Service Bulletin

JAGUAR

Bulletin: JD 01/86

DATE: DECEMBER 1986
SHEET: 1 OF 4
BULLETIN: JD12/86

FIG. 1

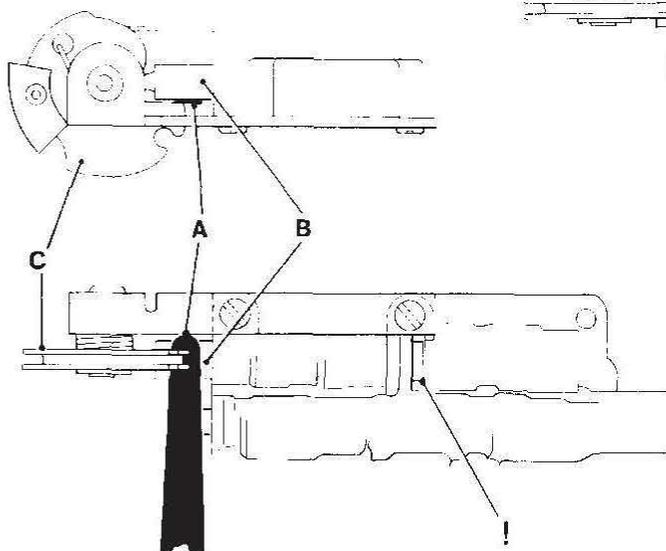
- 9) With the kickdown valve against the cam, an exhaust gap of 0,025 to 0,38mm (0.001 to 0.015 in) should exist between the valve land and the casting.

- a) Check visually that an exhaust gap exists, if no gap is evident proceed to operation 10.
 - b) The exhaust gap should be fully closed when a 1mm (0.040in) feeler gauge (A, Fig. 2) is inserted between the downshift valve (B, Fig. 2) and the heel of the cam (C, Fig. 2).

- c) If a gap is still evident then proceed to operation 10.
- 10) Loosen the two screws (A, Fig. 1) securing the cam bracket to the valve body and move the valve body until a gap exists. Repeat operation 9b and tighten the retaining screws.

FIG. 1

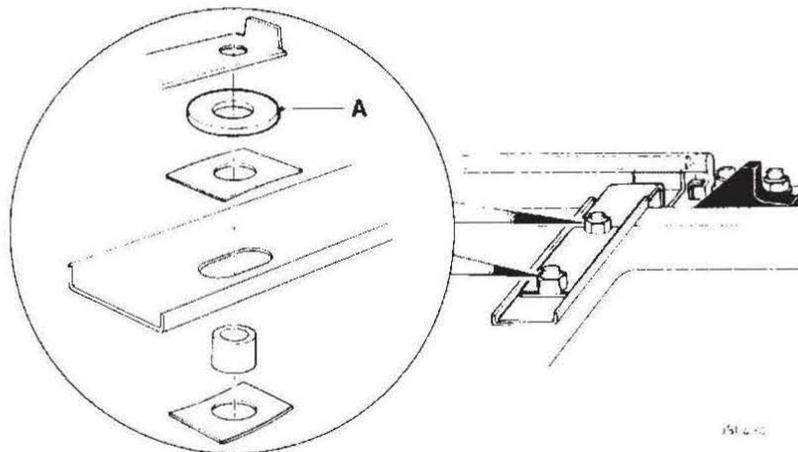
- 1) Rattles emanating from the rack cable mounting brackets on the sliding roof underpanel.
- 2) Creaks from contact between the roof headlining and the sunroof assembly.

- 1) Remove sliding roof panel.
- 2) Fully close underpanel, de-tab and remove the nuts and tab washers securing the rack cable brackets (Fig. 1).

- 3) Position one 10 mm I.D. plain washer over the distance collar of each stud "A" Fig. 1, to increase tension on the bracket. Refit tab washer and nuts, tighten and re-tab.

NOTE: When the nuts are tight the brackets must be able to slide on the mountings to allow cable movement during operation.

FIG. 1

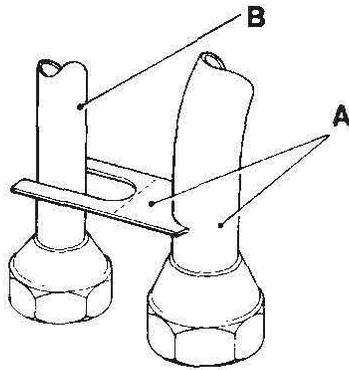
Following the introduction of the large bore low pressure refrigerant hose at VIN 424475, ref. Service Bulletin 05/85 Item 40, vibration problems have been experienced with the location bracket welded to the low pressure hose, See Fig. I (A).

To prevent a possible foul condition occurring between the bracket and the high pressure hose Fig. 1 (B), which can cause vibration and a metallic rattling noise being detected within the car, this location bracket is now being deflected upwards 90° after hose assembly (See Fig. 2).

This modification was incorporated at VIN 437067.

Should problems be encountered in service then the above modification should be carried out.

FIG.1

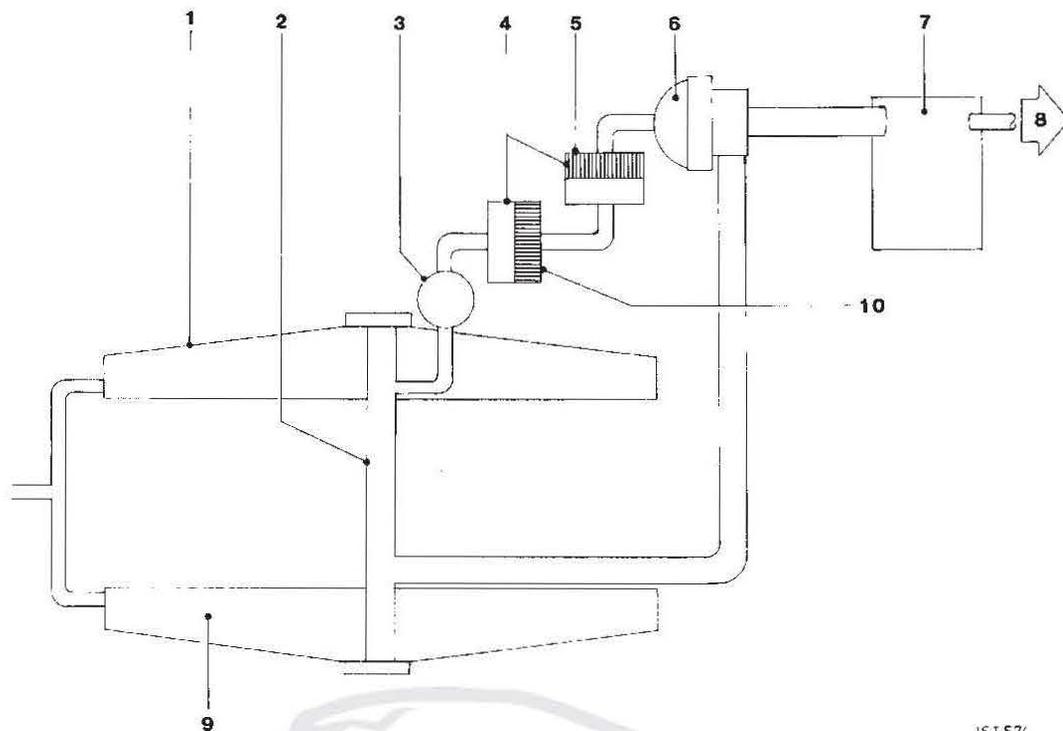
A revised purge control system with vacuum operated switching replacing electrical switching has been introduced on XJS V12 models providing a more stable idle condition when manouvering at low speeds (see Fig.1 on next page for schematic layout). This modification effectively delays carbon canister purging for a few seconds as engine speed increases just off idle, preventing a possible over-rich mixture.

The modification was introduced at VIN 133461 in conjunction with the fuel rail vacuum valve and will also be incorporated on V12 saloons in the future.

JSI-618

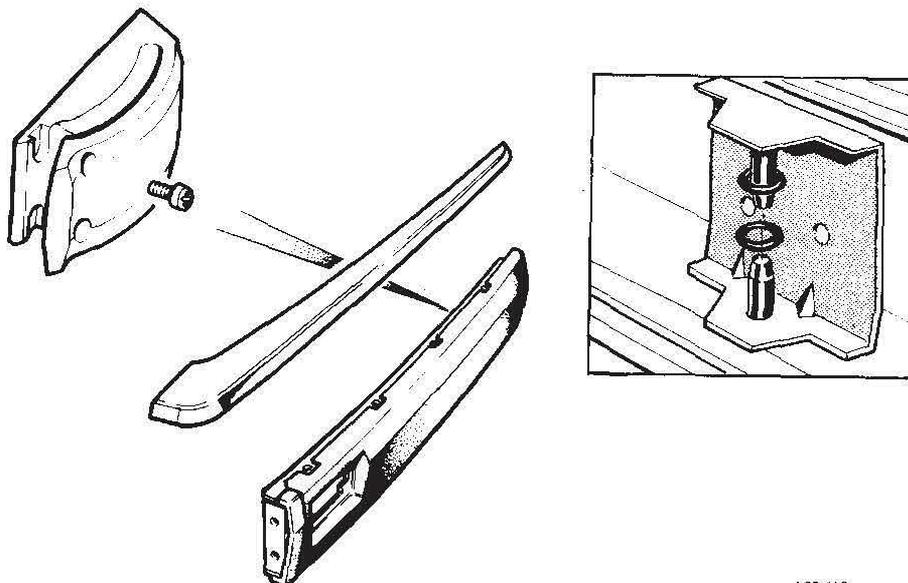
Investigations reveal that rattles from the rear bumper side blades on XJ6 2.9/3.6 models are due to excessive tolerance between the side beam mounting bracket pin and the side bumper locating bracket.

To eliminate the rattle, fit a rubber 'O' ring KRC 1152 to each beam mounting bracket pin.

All vehicles manufactured from VIN 501766 have been modified to this condition.

To rectify early vehicles, remove the bumper assembly, add rubber 'O' rings as indicated in the illustration and refit to the vehicle.

HSLP WIRING DIAGRAM

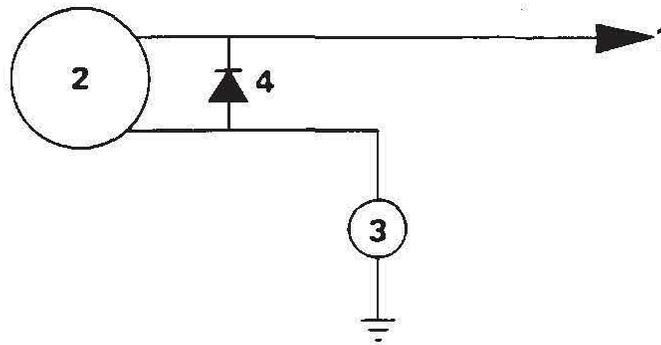
The thermal fuse and superheat switch system has now been deleted and replaced by a high side low pressure switch (HSLP) from Vins:

The superheat switch design was such that it detected super heated refrigerant vapour on the low pressure line.

The HSLP switch is designed to monitor pressure drop on the high side of the system. At a low pressure condition of 25 psi \pm 5 psi, the HSLP switch contacts, which are normally closed, open circuit, thus breaking the earth circuit to the compressor clutch coil resulting in the clutch drive disengaging.

FIG.1

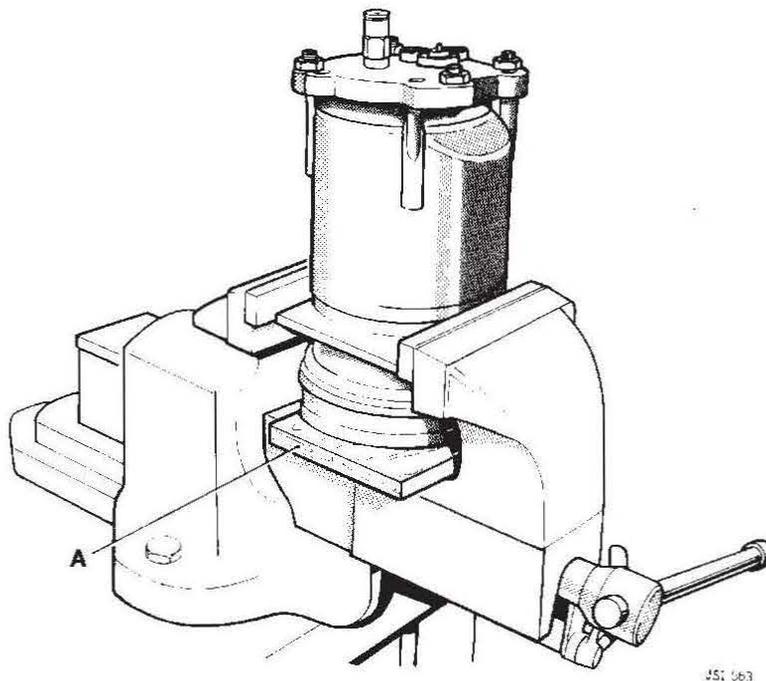
- 1) Disconnect battery
- 2) Depressurise the air conditioning system
- 3) Remove the compressor unit, and discard the thermal fuse, bracket and harness.
- 4) Place the compressor in a vice as shown in Fig.1 and grip using the forward mounting flange. Do not overtighten. As direct metal to metal contact can result in damage to the clutch drive, place a piece of wood (Fig.1 A) in the vice on which to rest the clutch drive.

IMPORTANT: THE COMPRESSOR MUST BE POSITIONED IN THE VICE AS SHOWN IN FIG.1 TO PREVENT LOSS OF REFRIGERANT OIL WHEN THE REAR HEAD IS REMOVED.

FIG. 2

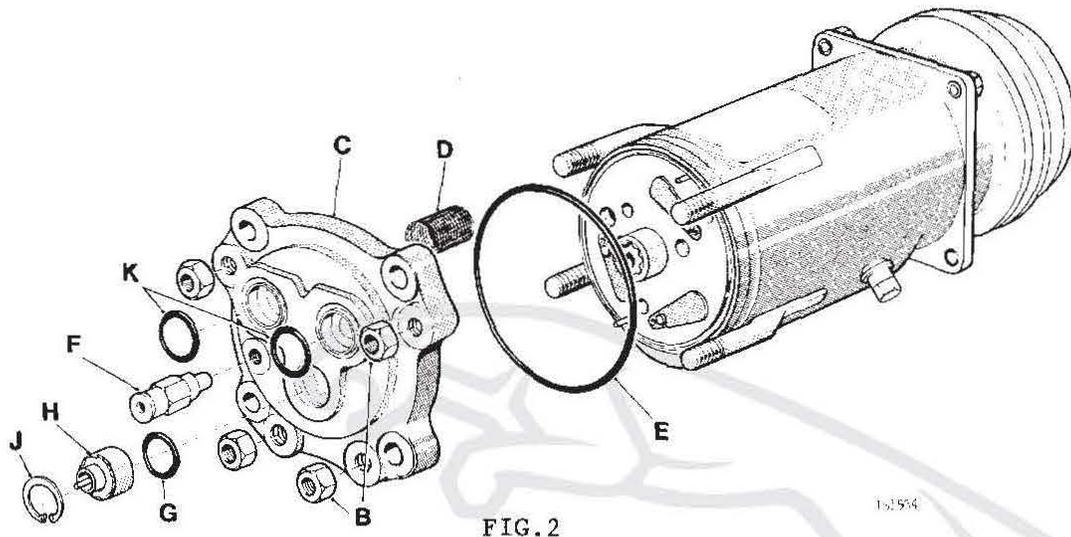
- 5) Release and remove the compressor rear head securing nuts 4 off (Fig.2 B).
- 6) Displace and remove the compressor rear head (Fig.2 C) and carefully remove filter assembly from rear head (Fig.2 D) and retain. Discard head.

- 7) Remove and discard rear head 'O' ring seal from main body of compressor (Fig.2 E).
- 8) Clean filter (Fig.2 D) and compressor seal face.
NOTE: BEFORE FITTING NEW 'O' RING SEALS LIGHTLY COAT WITH SUITABLE 525 VISCOSITY REFRIGERANT OIL.

- 9) Fit and align new rear head seal (Fig.2 E) to compressor body.
- 10) Fit filter (Fig. 2 D) into new rear head and align head to compressor. Tap rear head lightly until flush with compressor body. Fit and tighten securing nuts to 34 Nm (25 lbs ft).

- 11) Fit and secure new pressure relief valve (Fig.2 F) to rear head, and tighten to 13.5 to 19 Nm max (10-14 lbs ft max).
NOTE: The relief valve is supplied complete with the 'O' ring assembled. Lightly smear with 525 viscosity oil before fitting to rear head.

- 12) Fit the high side low pressure switch 'O' ring (Fig.2 G) supplied in the HSLP kit to the recess in the rear head location.
- 13) Carefully locate the HSLP switch (Fig.2 H) and push until it is correctly seated into the rear head location.

- 14) Fit circlip (Fig.2 J) and ensure it is fully located into the rear head.

- 15) Fit new 'O' rings to rear head high side and low pressure ports (Fig.2 K).
- 16) Refit compressor to vehicle and fit new harness supplied in kit.
- 17) Reconnect battery.
- 18) Connect and secure refrigerant hoses to compressor, evacuate and recharge system and check operation.
